# Product Change Notification

## 112783 - 00

**Change Notification #:** 112783 - 00  
**Change Title:** Intel® Server System R2208BB4GS9  
PCN 112783-00, Product Design  
Update System PSU Bracket  
**Date of Publication:** December 12, 2013

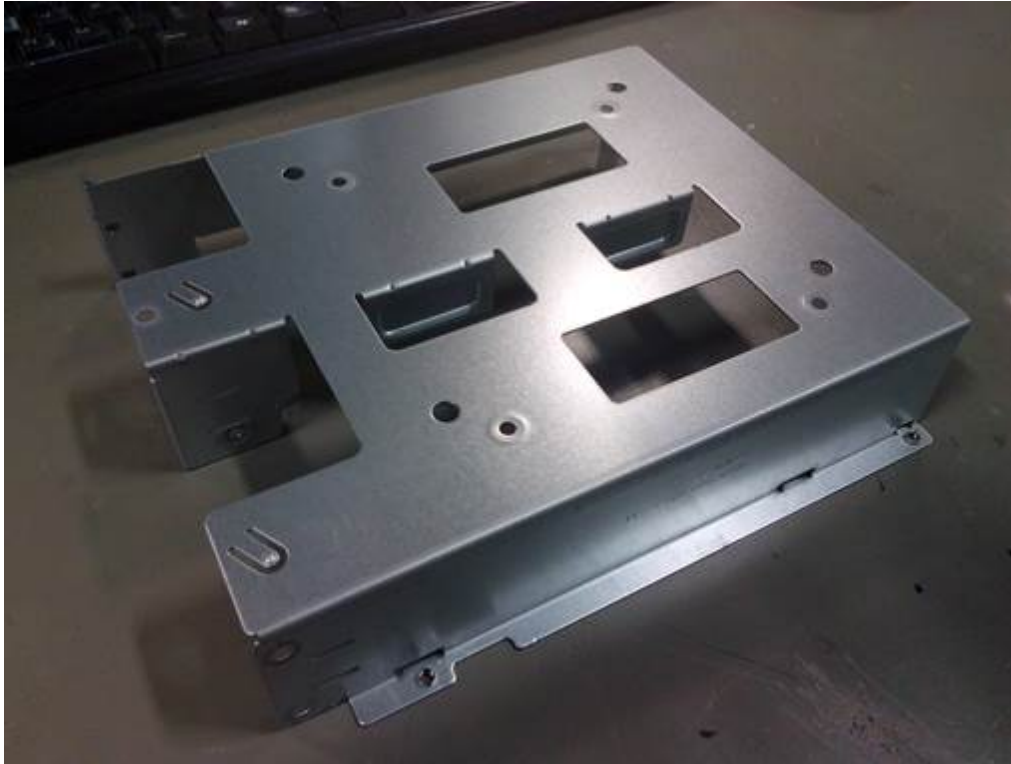
Update the Power Supply bracket to remove middle punch. Please refer to below pictures for details:

Pre-change:

Post-change:
